DIVISION Power Systems
TM 7996:70-629
DATE 17 July 1970
W.O. 1475-78-2000

TECHNICAL MEMORANDUM

TITLE: Design Review of PCS-G Condenser, P/N 1268340-1,
Redesigned from P/N 093043

SUBJECT LOADS ON CONDENSER STATUS

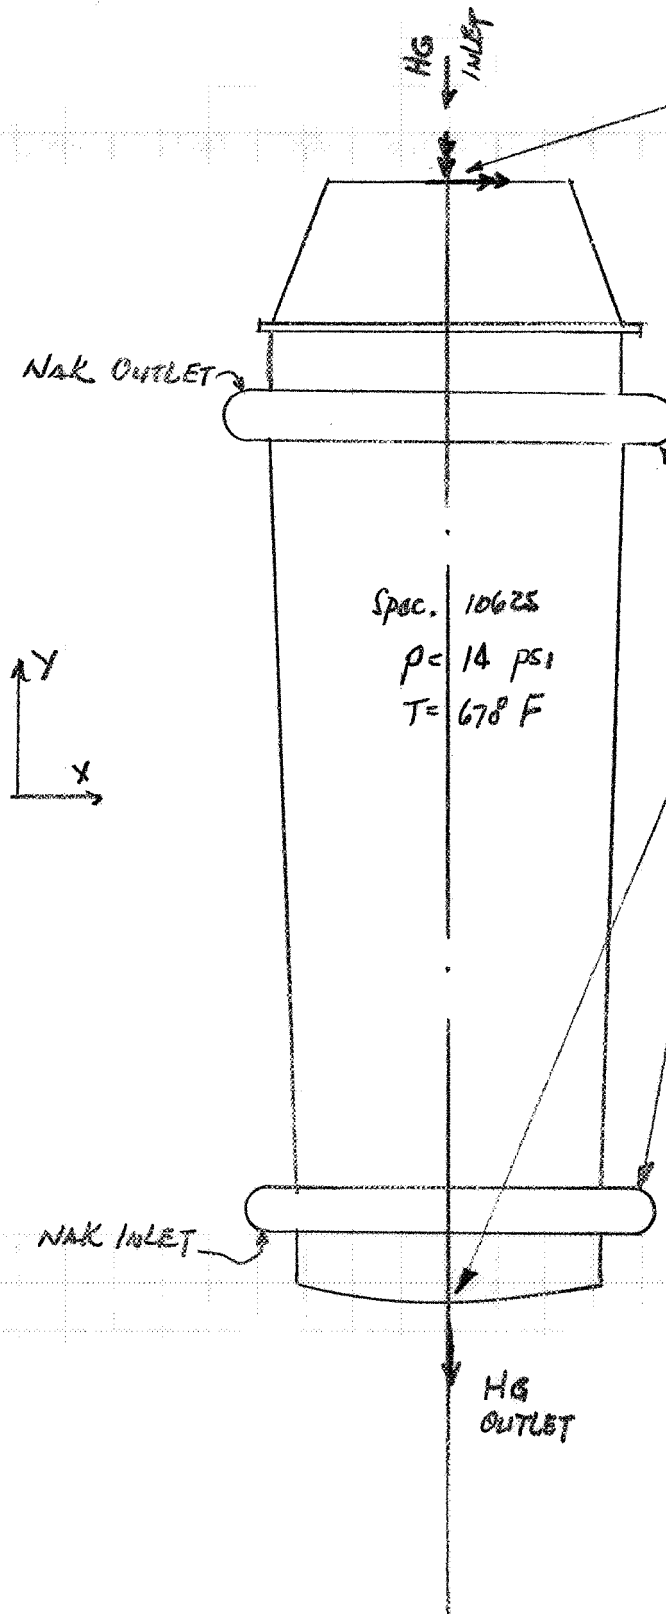
Results of the Finite Element Analysis using IBM Computer Program E11401, indicate that critical part is the low carbon steel (C-1015) area which has an allowable

1. Low carbon steel C-1015 part of the assembly be replaced by a higher strength metal.
2. Accept this part based on AGC Specification 10625, Para. 3.1.2.3.1 for 100 startup and shutdown sequences of operation during its operating life.
3. Conduct structural analysis of the integrated system to evaluate the effects of the mounts and supports structure.

PLENUM MERCURY EXIT

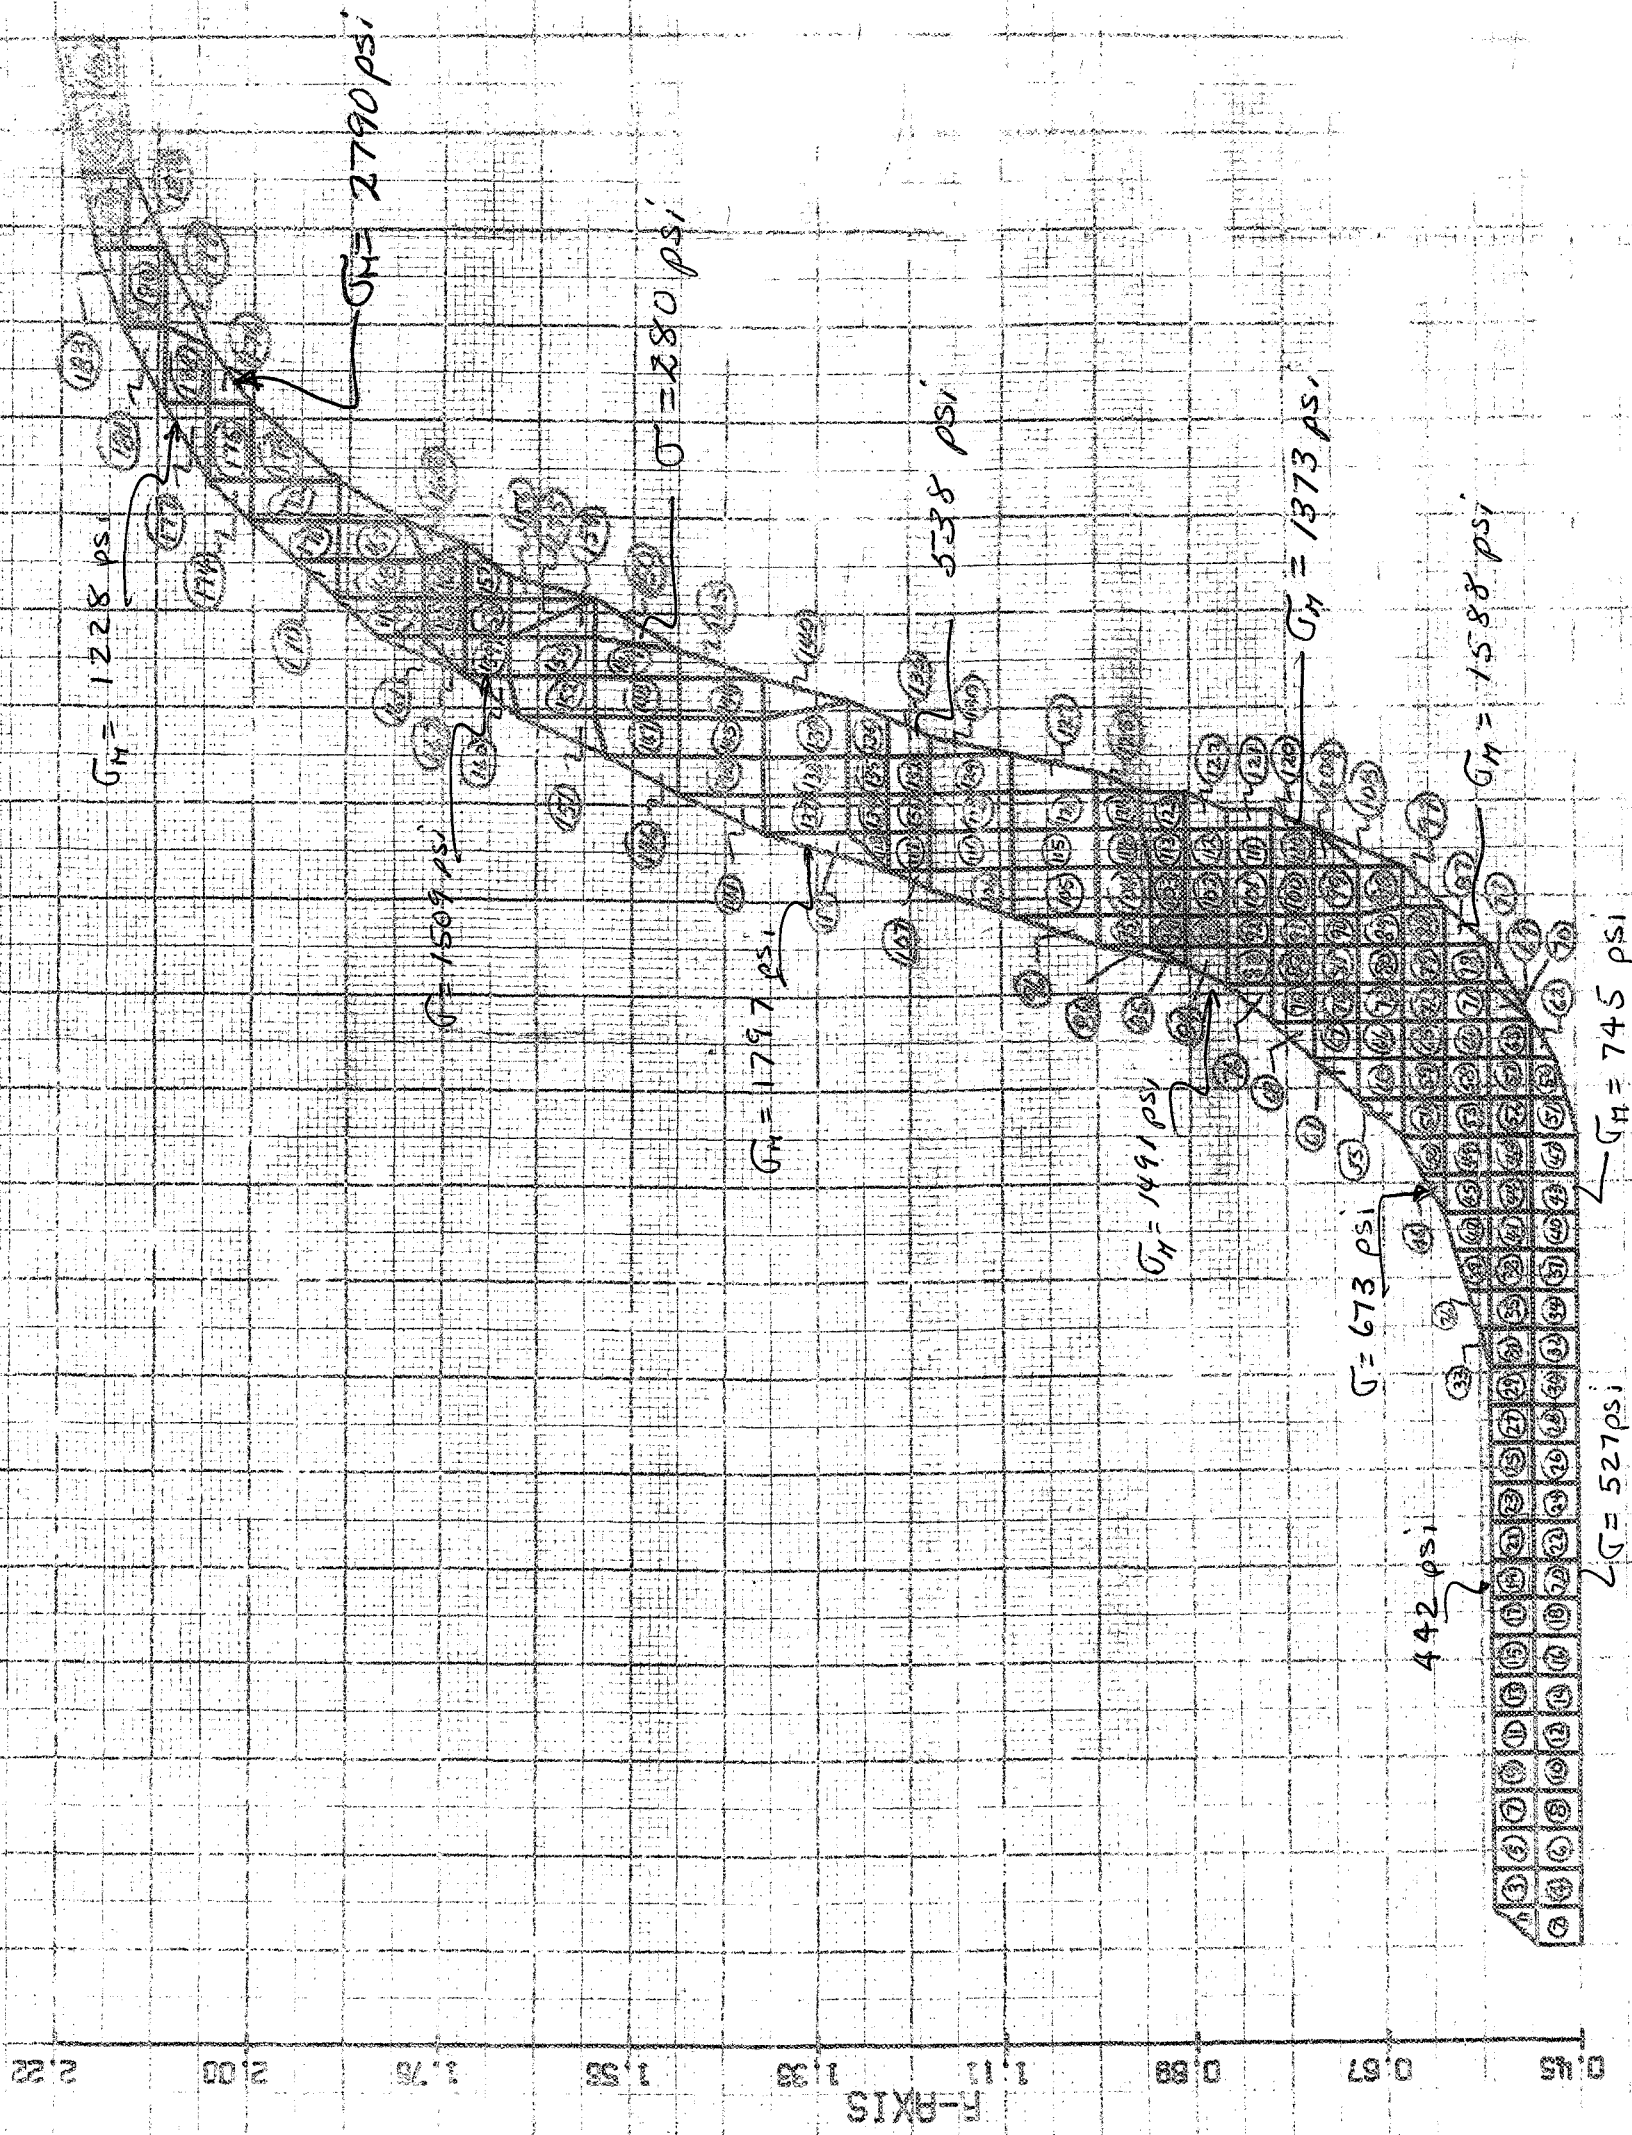
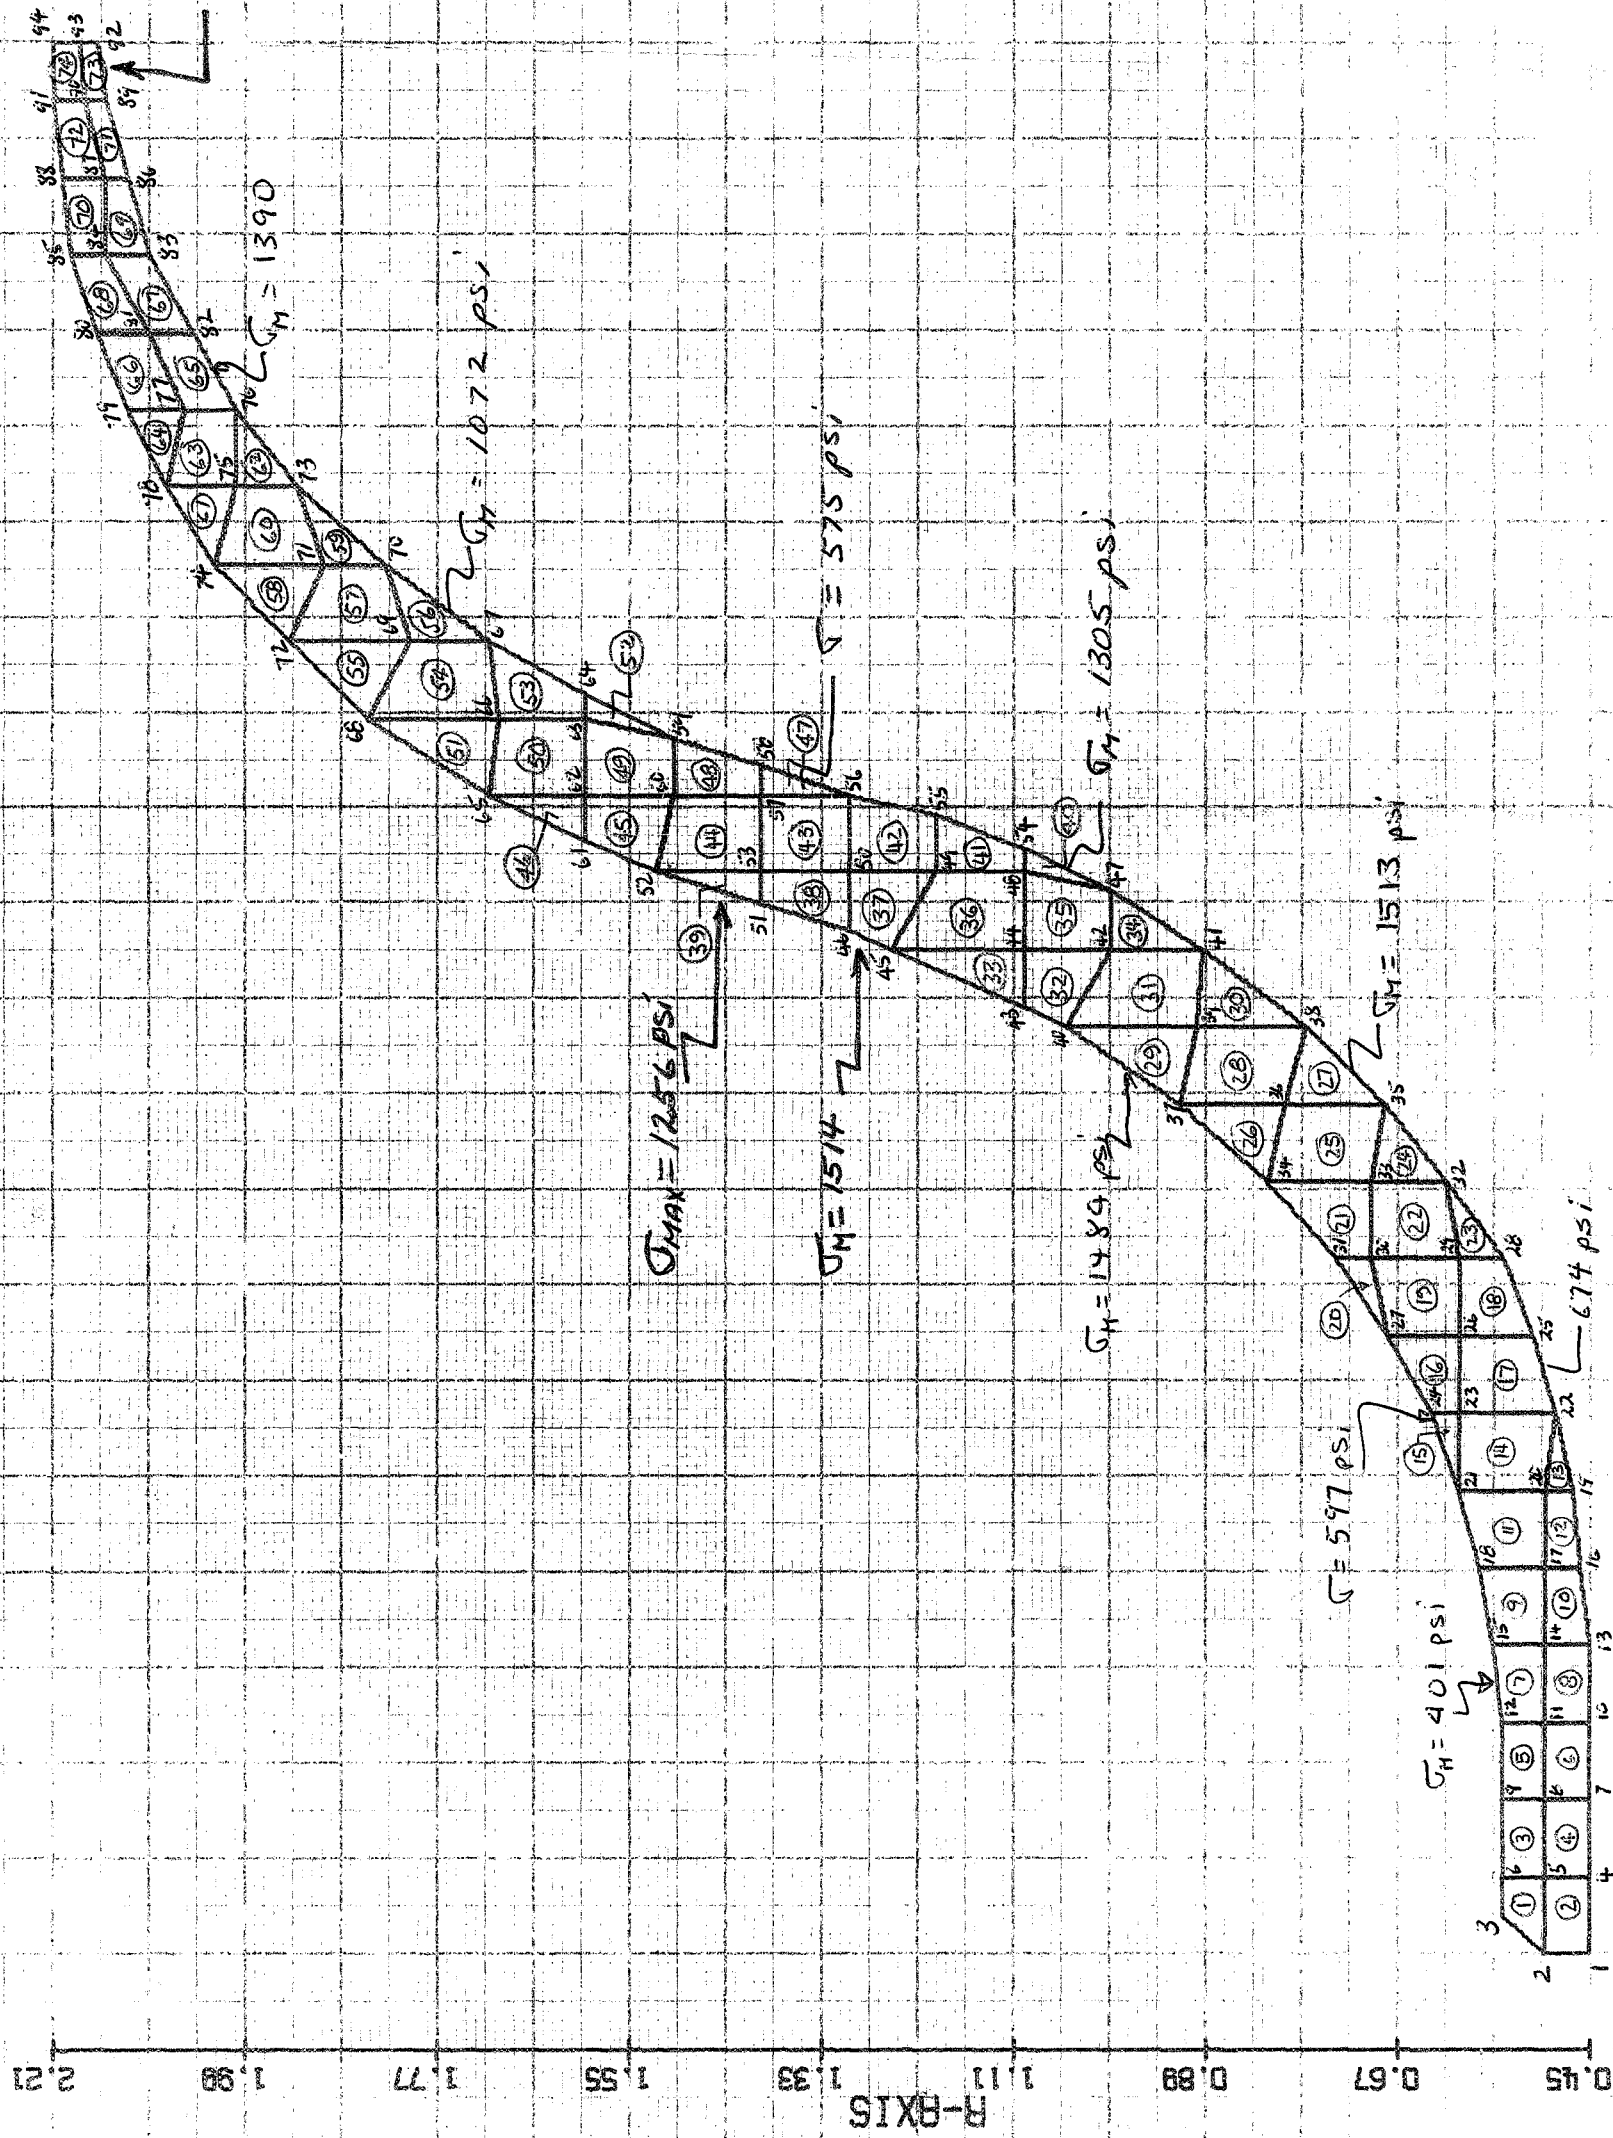
Results indicate low stress levels at all points of shell. No critical zones. Maximum stress levels are:

Config. #1 - Element #176 - $\sigma_{Max.} = 2790$ psi

Config. #2 - Element #73 - $\sigma_{Max.} = 2472$ psi

Accept design as shown.
